Work Order ID 55697

Item Name: Basket Hoop

DESIGN #	DRAWN BY CP	DART AEROSPACE LTD HAWKESBURY, ONTARIO, CANADA	
CHECKED #	APPROVED #	DRAWING NO. D3166	REV. A SHEET 1 OF 1
DATE 02.07.10		TITLE BASKET HOOP	SCALE NTS
A	02.07.10	NEW ISSUE	
A1	04.04.08	38+/-1 was 36.0

DRAWING NO. D3166	TITLE BASKET HOOP	REV A1	DART AEROSPACE LTD ENGINEERING ORDER		D.E.O. NO. D3166-A-2	SHEET NO. 1 OF 1	SCALE NTS
DRAWN AJS	CHECKED 1	MFG. APPR. M	APPROVED MP		DE APPR. H		
DATE 08.12.11	DATE 08.12.15	DATE 08/12/15	DATE 08/12/16		DATE 08.12.16

D3166-1 BASKET HOOP

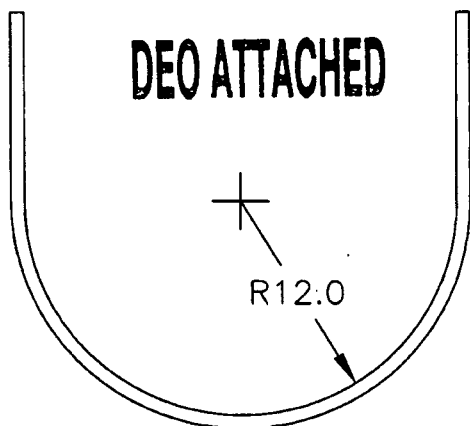
1) MODIFY MATERIAL NOTE FOR D3166-1 AS SHOWN:

1) MATERIAL: AISI 304/316 SS SQUARE TUBING,
0.75" x 0.75" x 0.063 WALL, 60.00" LONG
(REF DART SPEC. M304TS0.750W.063)

1) MATERIAL: AISI 304/316 SS, 3/4 X 3/4 X 0.065 WALL SQUARE TUBING,
60.00" LONG
REF. DART SPEC M304TS0.750W.065

D3166-3 BASKET HOOP

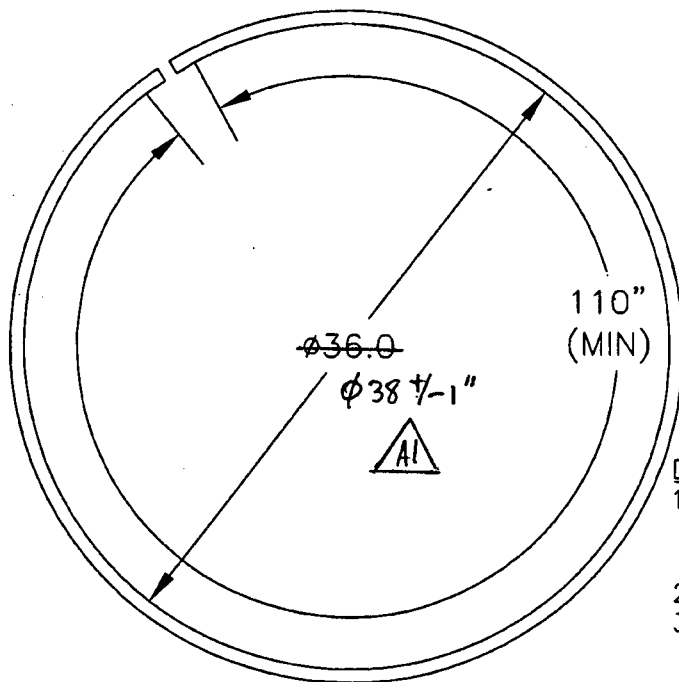
2) MODIFY MATERIAL NOTE FOR D3166-3 AS SHOWN:

1) MATERIAL: AISI 304/316 SS SQUARE TUBING,
0.75" x 0.75" x 0.063 WALL, 120.00" LONG
(REF DART SPEC. M304TS0.750W.063)

1) MATERIAL: AISI 304/316 SS, 3/4 X 3/4 X 0.065 WALL SQUARE TUBING,
120.00" LONG
REF. DART SPEC M304TS0.750W.065
